List of changes:

chipkarte_atm
5/24/11 4:47 PM
Sheet: 1/1

Programming interface

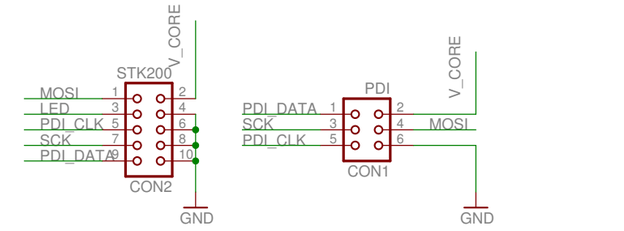
Fixed HW bug: MOSI(PDI_DATA) and MISO have been interchanged. Fixed now.

XMega16A4 / XMega32A4 with extension port

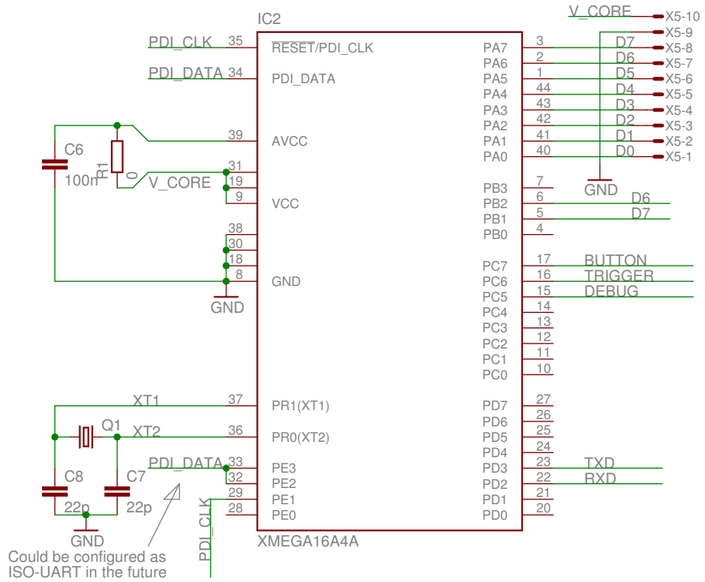
D6 / D7 are connected to ADC / DAC pins now.
This enables, e.g., adding a microphone and a speaker.

AREF & AVDD was not shorted to Vdd. Fixed now.
